May 24, 2016

Re: United Hospital Redevelopment FEIS Review
Village of Port Chester, Westchester County, New York
MC Project No. 15001515A

A. Summary of Major Concerns of the FEIS

May 2016
I-287 Exit 11 Traffic Counts and
Comparisons

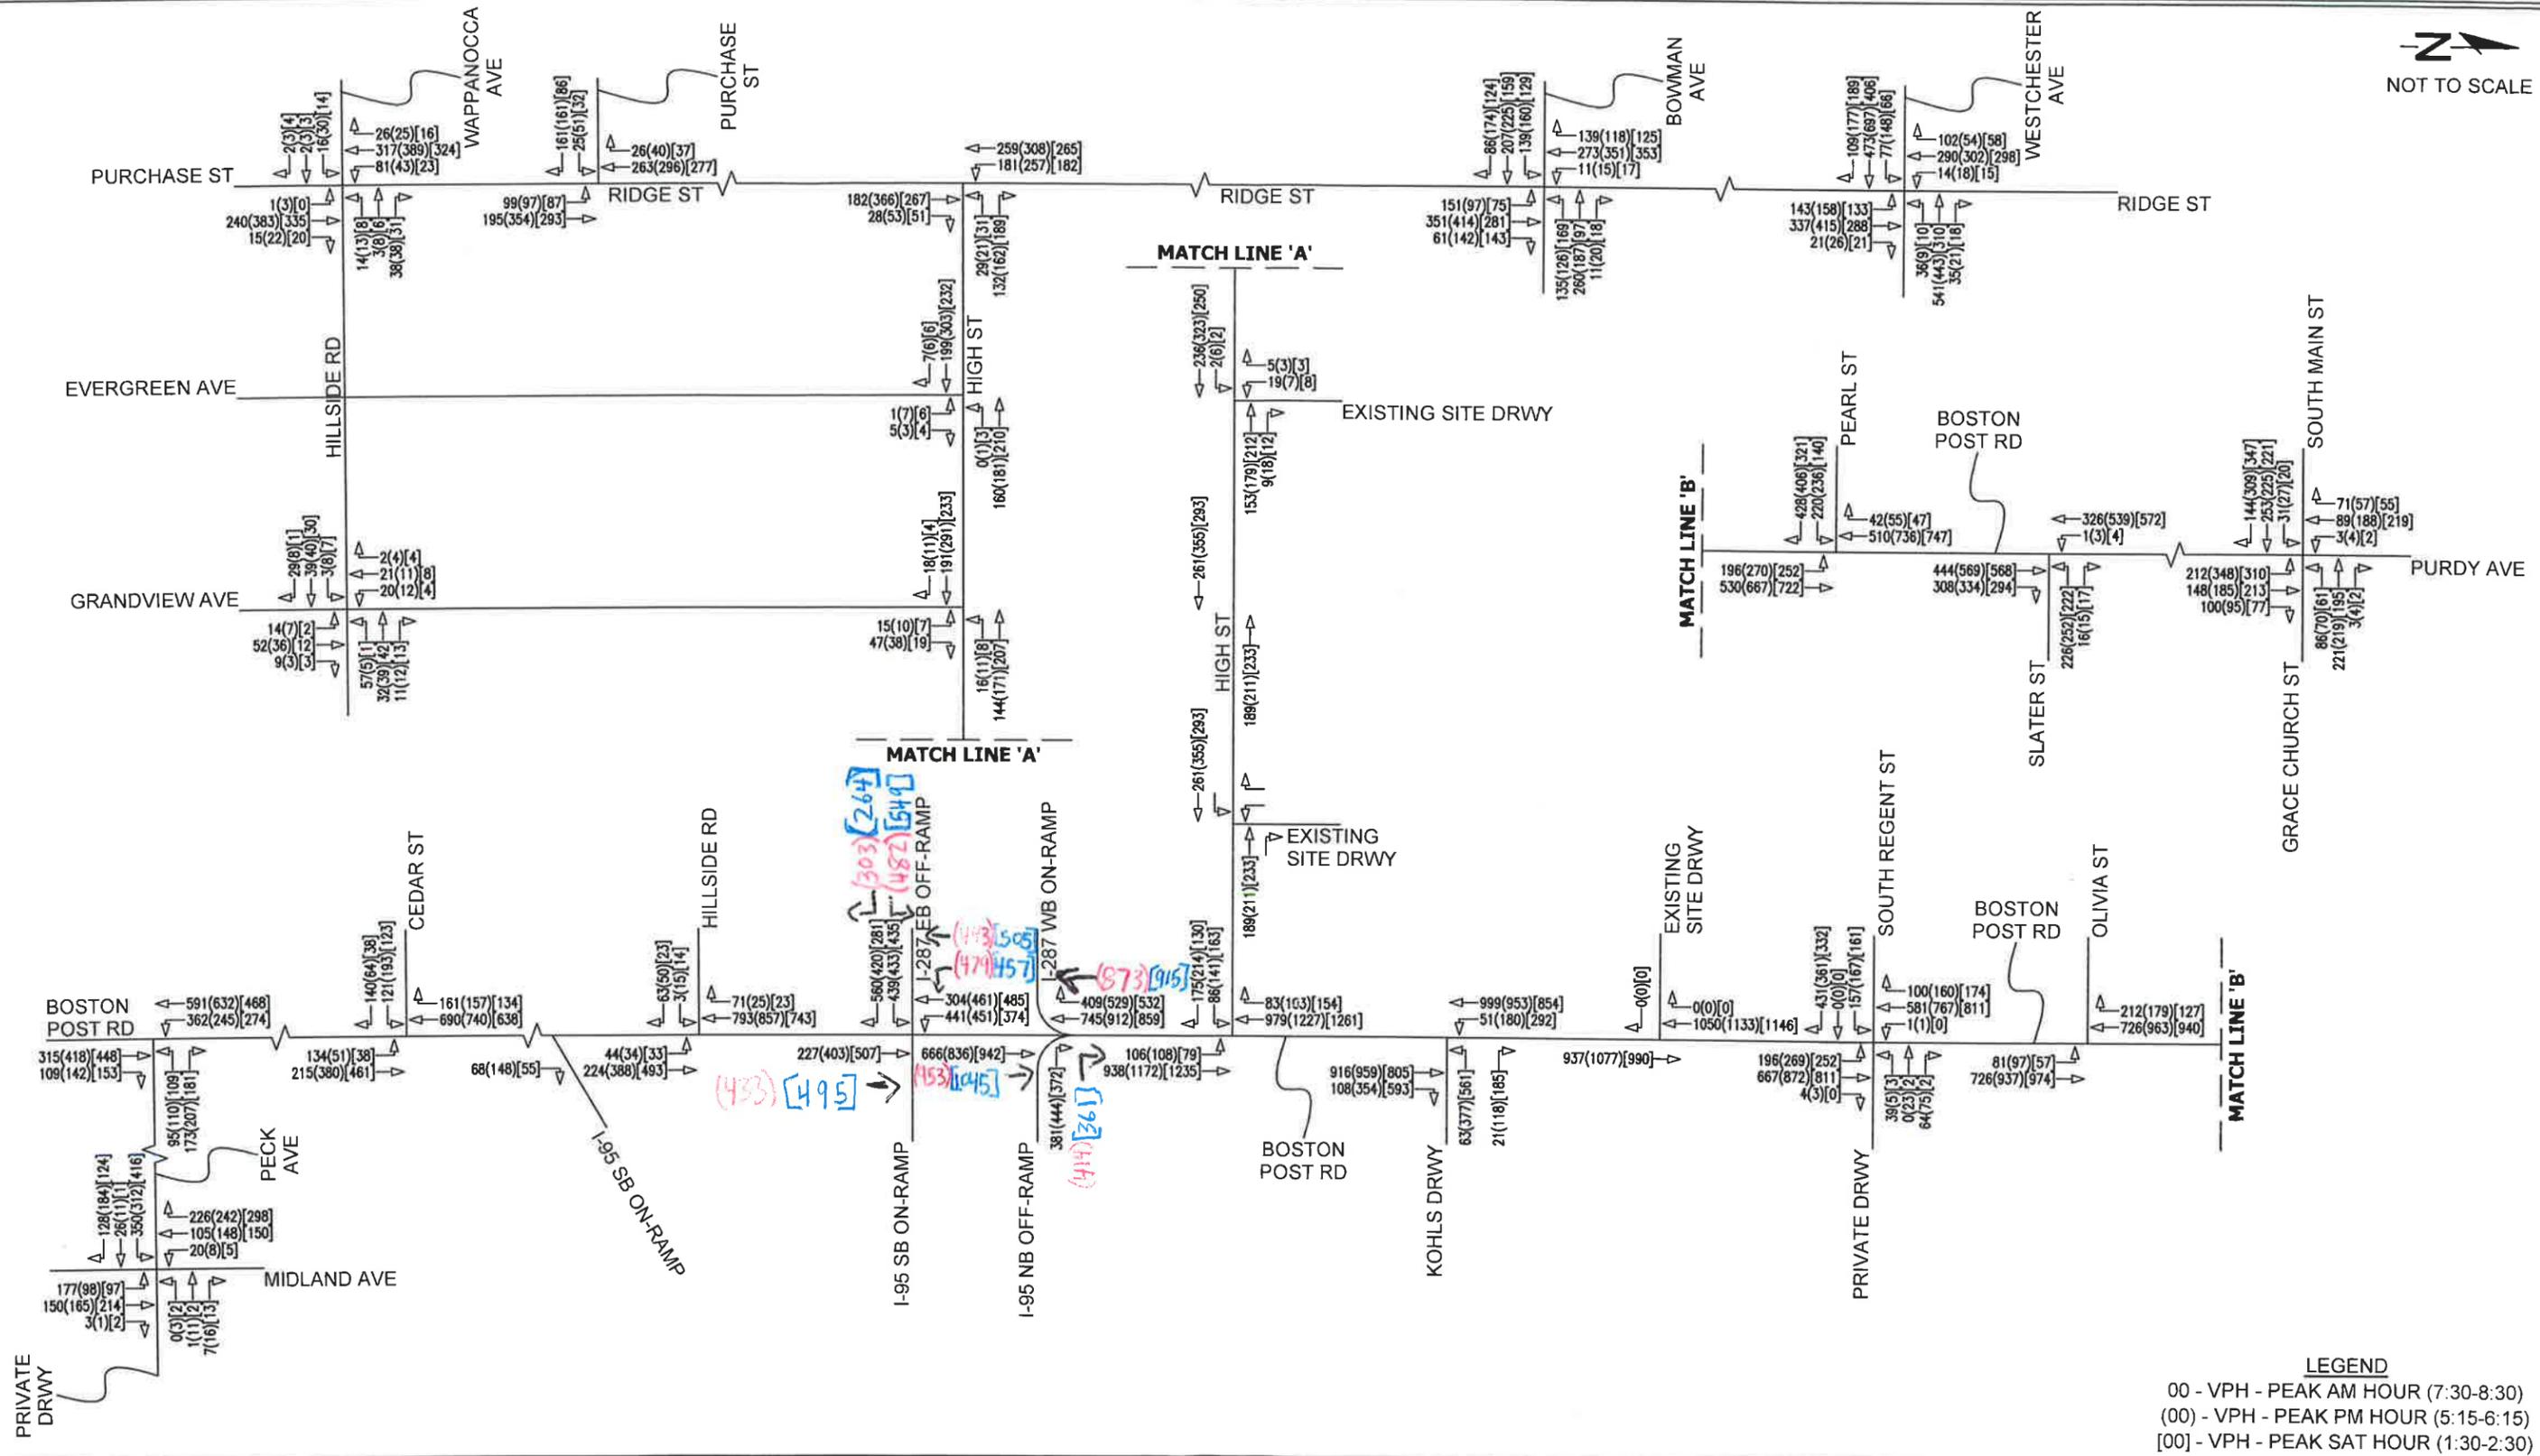
It should also be noted that recent traffic counts collected by our office at this intersection on Friday May 6th and Saturday May 7th, 2016 indicate during the Saturday peak hour, **the left turn volume from the ramp was observed to be in excess of 100 vehicles higher than the base volume used in the UHR Traffic study (549 vs. 435). The southbound left from U.S. Route 1 onto I-95 southbound was in excess of 75 vehicles higher (457 vs. 374).**

Double Left Turn Lane Capacity Adjustments

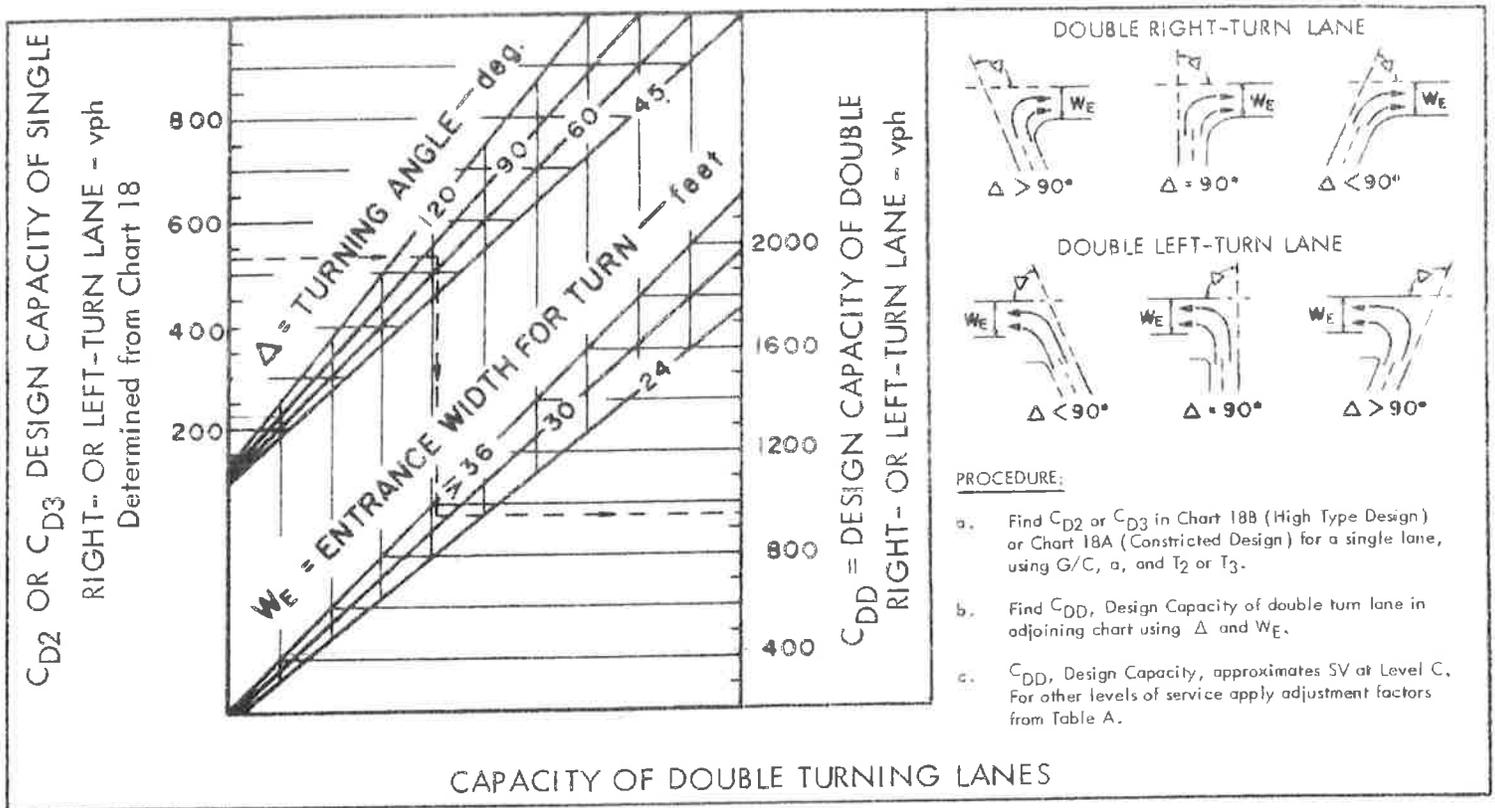
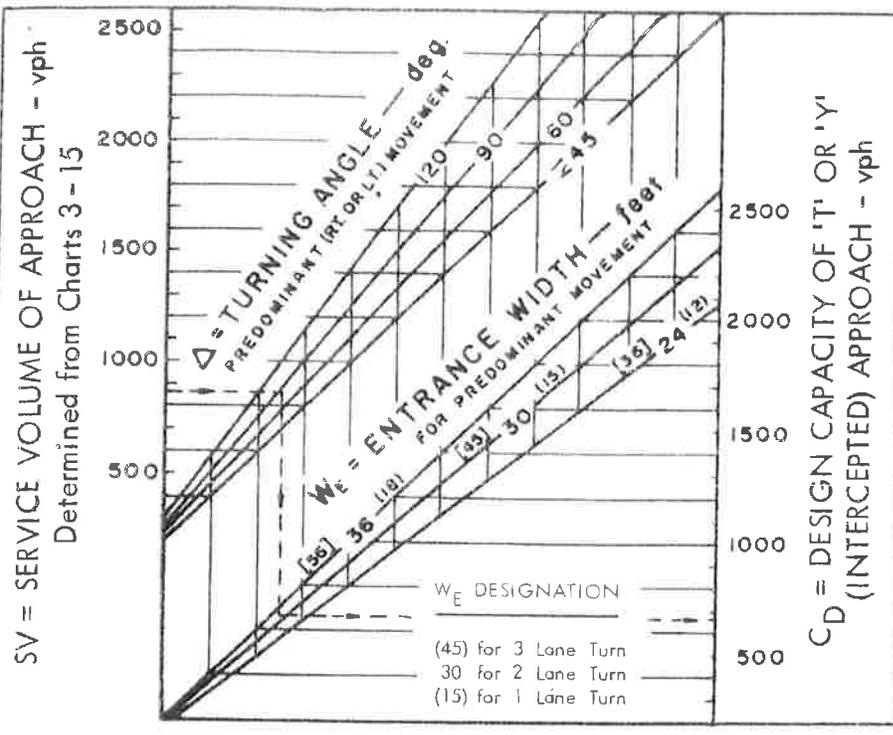
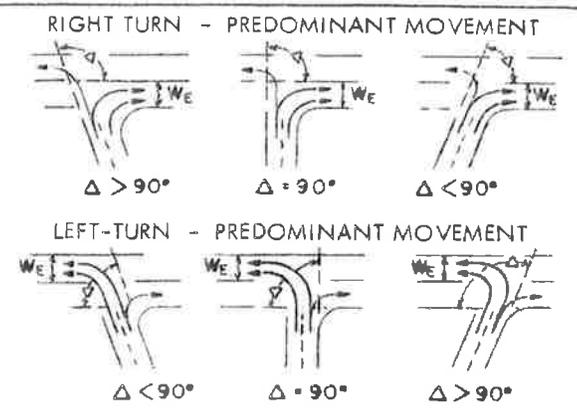
3. Historical information provided in the previous editions of the Highway Capacity Manual indicates that logically, the capacity of a dual left turn lane is impacted by the angle of an intersection as well as the width of the receiving lanes for this dual movement. For example, see the attached Charts 22 and 23, which are based on data and research dating back to the 1965 HCM. Specific to the site access intersection, the double left turn lane capacity would be reduced due to the limited width of the receiving lanes (i.e. two 11-ft. lanes) as shown in the charts, which is not accounted for in the Applicant's analysis. At the intersection of U.S. Route 1 and the I-287 Eastbound Off-Ramp, the capacity of the double left turn lane from the eastbound off-ramp is impacted by both the angle of the intersection and the limited width of the receiving lanes (approximately 23-ft.). Based on the Charts, the capacity of the double left turn lane when compared to a standard 90° intersection with a 36 ft. wide receiving lane to accommodate the turning vehicles is reduced by approximately 45% when accounting for the angle and width of the receiving lane, which the Applicant did not appropriately account for. Note that this reduction in capacity would occur regardless of the Applicants proposed improvements. The proposed improvements will also increase the traveled distance for a left turning vehicle using the

outer lane, which would further reduce the capacity of the intersection. Therefore, it is our opinion that the adjustments made by the Applicant are not sufficient to reflect actual and projected future operating capacities.

Potential I-287 Bridge Widening and I-95 Ramp Improvements/Signalized

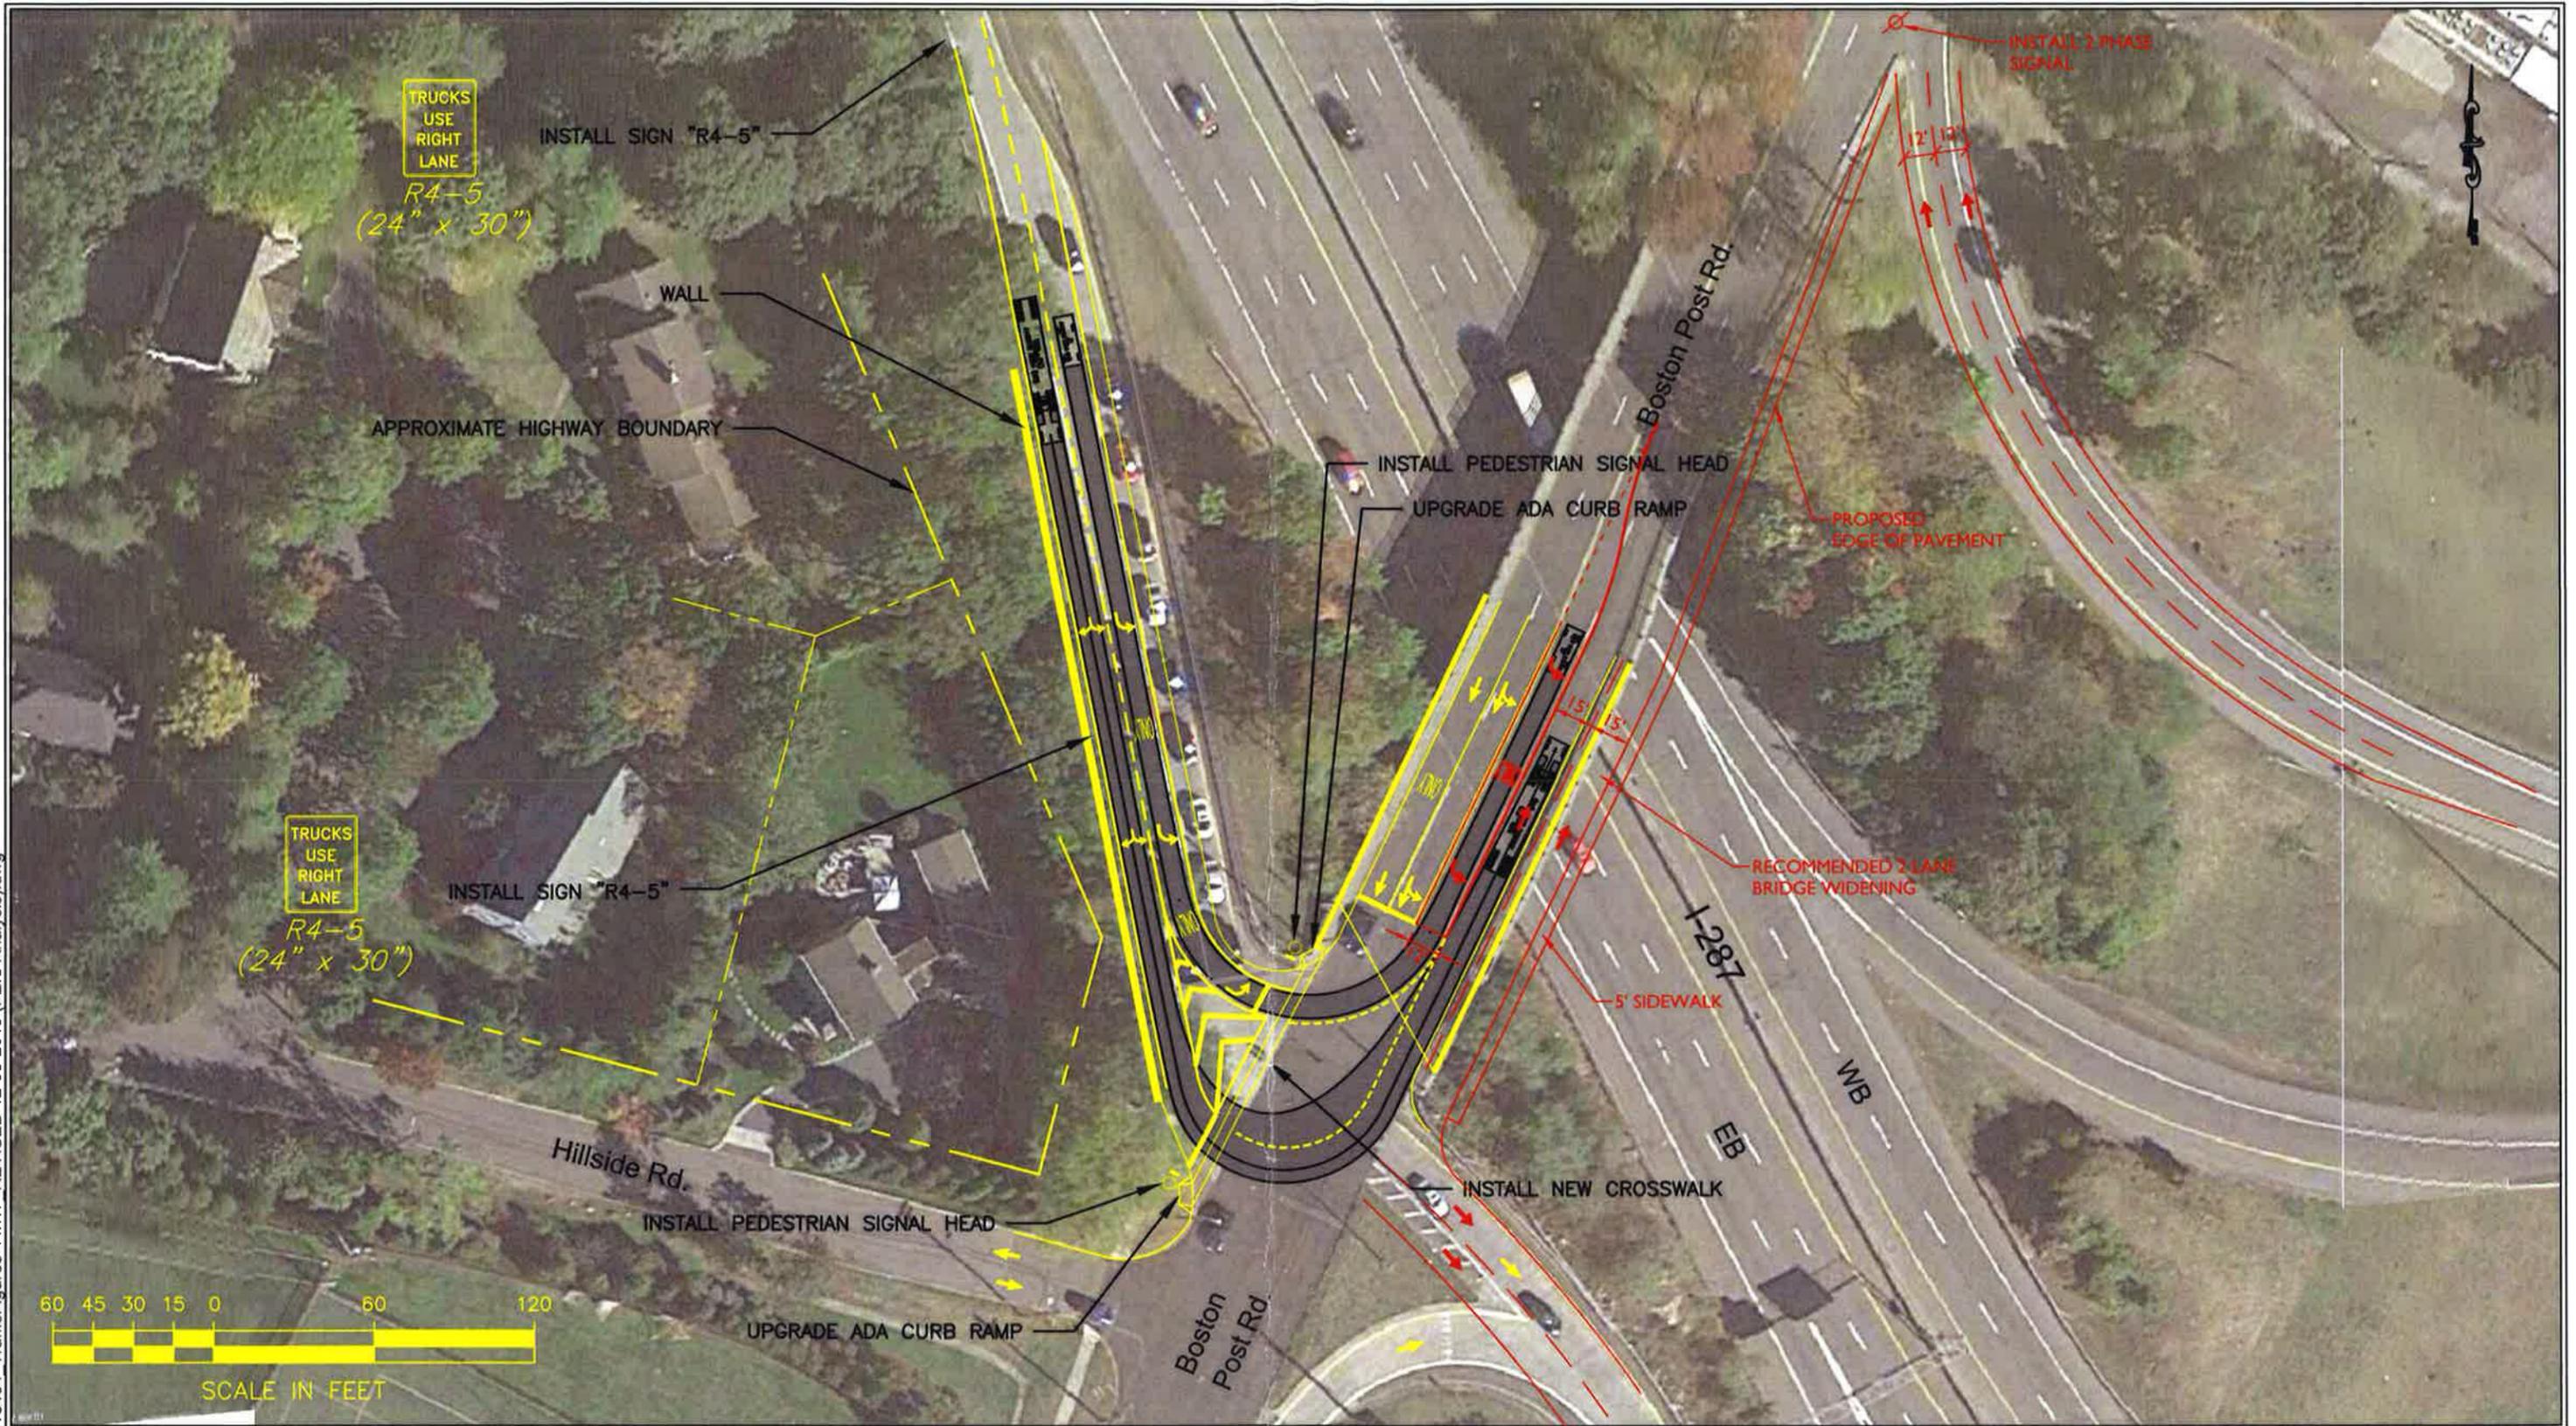
The Applicant continues to portray a dual turn lane (i.e. left and shared left/right) movement from the ramp onto U.S. Route 1. A concept for how this widening can be accomplished is provided on Figure III.E-27 of the FEIS, which includes the construction of a retaining wall on the east side of the ramp and striping to separate the left turn movements. **The Approximate Highway Boundary lines identified on the plan should be verified to determine if this work is feasible.** The Applicant has now attempted to consider the severe angle of the left turn movements exiting the ramp, which impacts the capacity of the approach. It should be noted that the proposed improvements would reduce the angle somewhat. However, it is our opinion that the adjustments made by the Applicant are not sufficient based on our observations of traffic, other historical data as well as the present restricted width of the bridge approach proposed width to receive this dual turn movement. **Even with the Applicant's improvements and adjustments, the analysis indicates that the left turn movement from the ramp will operate over capacity under future build conditions with vehicle**

queues extending from the ramp onto the mainline of I-287 eastbound. Similar concerns were raised in the Adler Consulting memo to the Village of Port Chester dated April 1, 2016. As a result of a meeting we attended on May 20, 2016, we understand that the Applicant's Engineer will be revising their plan and analyses to indicate their new proposal for widening to provide three lanes on the exit ramp. This plan would maintain a right turn lane for traffic heading towards Rye from the ramp.

4. Figure III.E-27 depicts a WB-50 vehicle making a left turn from the improved I-287 Eastbound Off-Ramp to U.S. Route 1 Northbound alongside a passenger vehicle making the same maneuver. The WB-50 vehicle is no longer an accepted ASSHTO Design Vehicle. The Applicant should be required to show that a WB-62 vehicle can also make this maneuver or limit the size of vehicles used for deliveries. Based on current conditions; vehicles larger than WB-50 sized vehicles currently utilize this exit ramp to access U.S. Route 1 northbound and these uses by such sized vehicles are expected to increase with the UHR project.

1. I-287 Exit 11 ramp and bridge improvements as identified above.
2. A Fair-Share contribution to the City of Rye for future improvements at the Peck Avenue/Midland Avenue intersection. The amount of this Fair-Share contribution is currently proposed to \$34,500 based on the Applicant's estimates and the amount of site generated traffic projected to travel through this intersection. Since there is uncertainty in the Arrival and Departure distributions utilized in the study we would recommend this contribution be increased to \$150,000, to account for potentially higher traffic volumes and the need for traffic signal upgrades.
